ROAD SAFETY AUDIT

Title: STAGE 1 ROAD SAFETY AUDIT

Office Innovation Campus, Moygaddy, Co. Meath.

Report reference: 1388R01

3.1 Problem

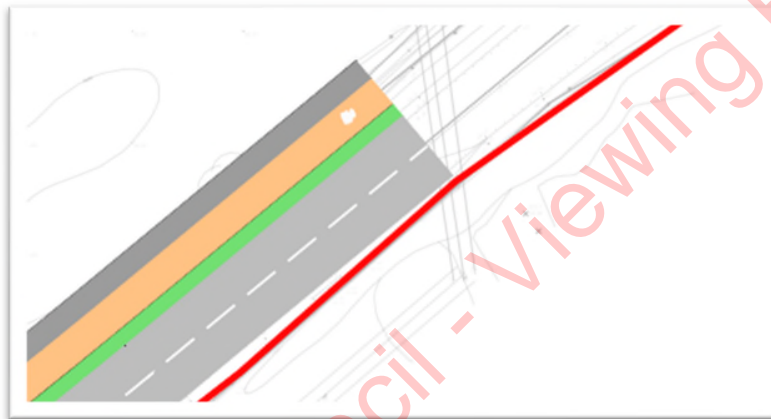
General Comment tie-in points

Details have not been provided of how the cycle track and footpaths will tie in at the scheme extents. Cyclists and pedestrians will have to cross the carriageway to access the facilities. Without suitable transitions from off road to on road and suitable crossing facilities there is a risk that pedestrians and cyclists will be struck by passing traffic.

It is recommended that suitable transitions and crossing facilities be provided.

3.1	Y	Y	The proposed cycle lane along the R157 eastern arm will be updated to tie into the carriageway. A suitable Jug turn will be provided on the opposite side of the road to accommodate the cyclists' right turning movement towards the development	Yes

Drawing S665- OCSC-1A-MH-DR-C-0111 S2 P01 Sheet 2 of 3, cycle track across campus access road.

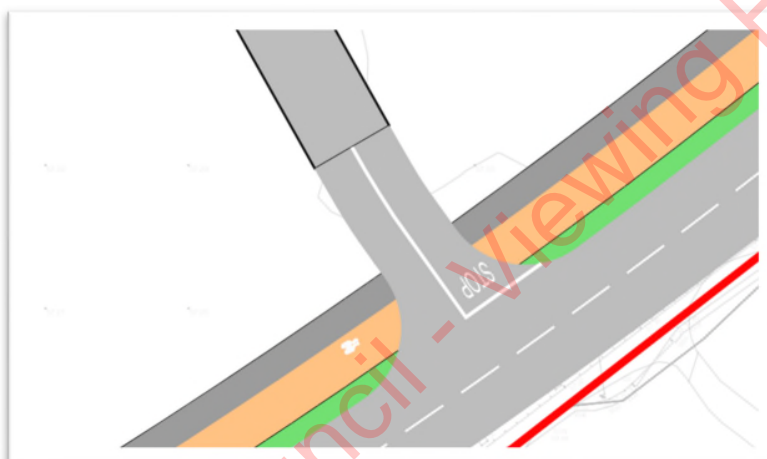
The proposed two way cycle track crosses the mouth of the campus access road. There is a risk that drivers exiting the campus may not expect two way cyclists as they approach the stop line.

It is recommended that a 'bend out crossing' be provided.

3.2	Y	N	It is proposed to provide a shared space and tactile for crossing before the cyclist and pedestrians approach the junction. A raised crossing will be provided to indicate priority for pedestrians and cyclists.	Yes

Drawing S665- OCSC-1A-MH-DR-C-0111 S2 P01 Sheet 2 of 3, campus access road.

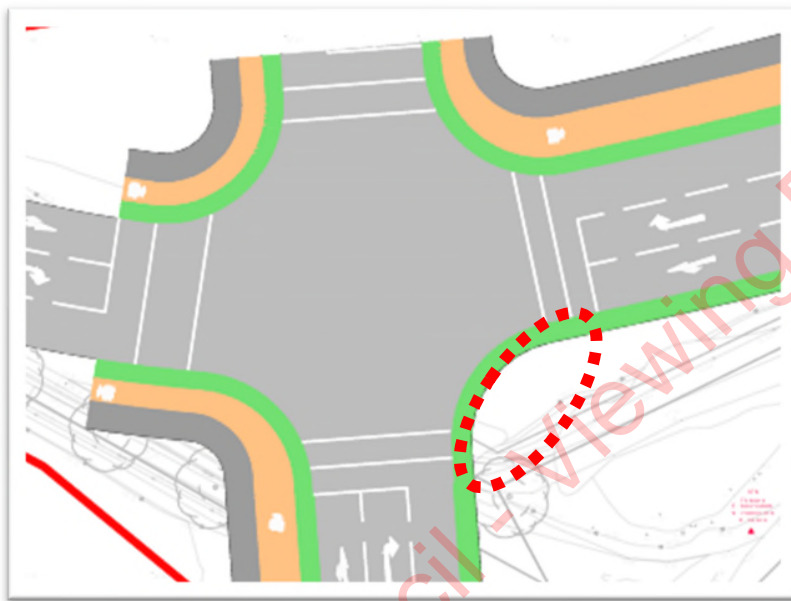
There is a signalised pedestrian crossing of the R157 eastern section, however there is no footpath on that side. This could lead to slips and falls if pedestrians cross into the grassed verge.

It is recommended that a section of footpath be provided linking the north-south and east west pedestrian crossing areas. The crossing should be retained to be able to cater for potential future development.

3.3	Y	Y	A shared facility has been provided within the campus at required widths which ties into the external pedestrian and cyclist network.	Yes
3.4	Y	N	There are insufficient spaces to provide walkways and cycle lanes along the south-eastern parts of the design (boundary wall). As such, two way movements will take place on the opposite sides. Pedestrian crossing lines have been removed from the junction on the eastern and southern legs.	Yes

Drawing S665- OCSC-1A-MH-DR-C-0115 S2 P01, Visibility Splay at Campus junction.

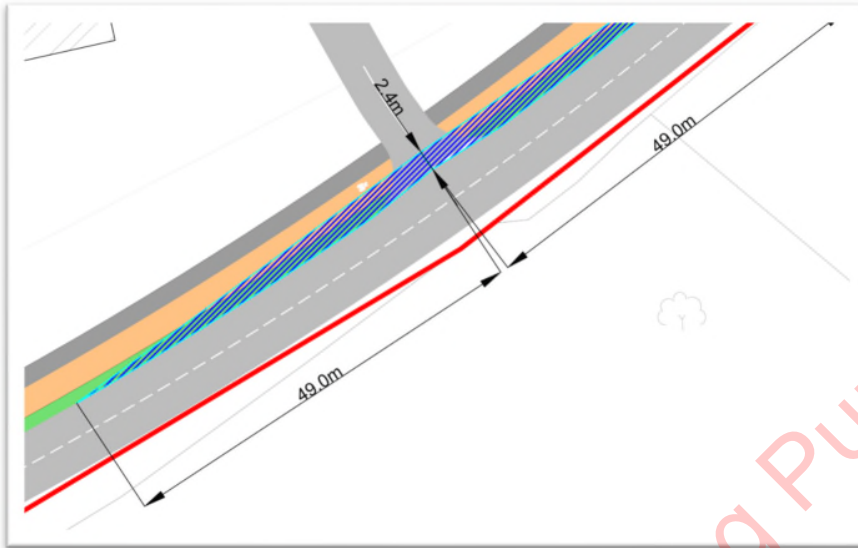
The visibility splay is shown for a 50km/hr urban design speed. The posted speed is 80km/hr. There may be insufficient visibility to oncoming vehicles leading to side-impact or rear-end collisions.

It is recommended that visibility splays be provided to match the anticipated 85th percentile speed post opening.

3.5	N	N	The visibility splay is achieved for 50kph. The speed limited will be lowered to 50kph once the new	Yes

distributor road and development is completed	
3.6	Y	Y	It is proposed to utilize the existing R157 road alignment as an off-road trail truck. The gate can be accessed via this trail in future once the development is completed.	Yes
3.7	Y	N	The proposed 1.5m verge separation is an improvement to the existing condition. As the section of road is fairly straight and the speed is being reduced, it is not anticipated that this would be a problem.	Yes

Drawing S665- OCSC-1A-MH-DR-C-0111 S2 P01 Sheet 2 of 3, Carton Estate gate.

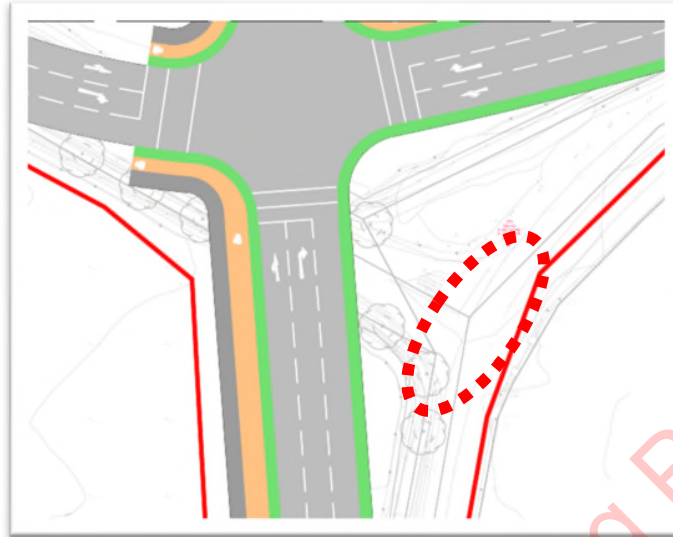
There is an existing gate into the Carton estate close to the proposed signalised junction. It is unclear if this gate will be used in the future. If it is to be used movements into and out of it may lead to collisions at the junction.

It is recommended that the accommodation works relating to this gate be included in the design process.

Drawing S665- OCSC-1A-MH-DR-C-0111 S2 P01 Sheet 2 of 3, Carton Estate boundary wall.

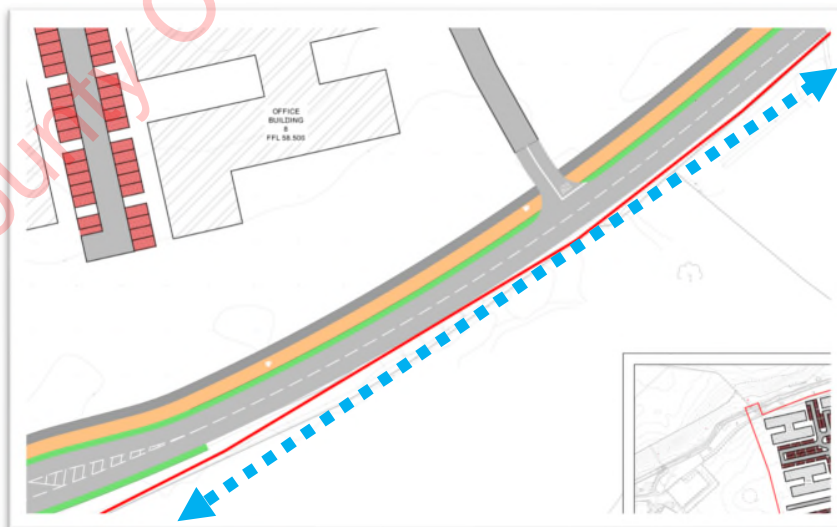
The realigned R157 eastern arm is very close to the stone wall of the Carton Estate. This is a hazard for an errant vehicle.

It is recommended that a suitable Clear Zone be provided between the boundary wall and the realigned carriageway.
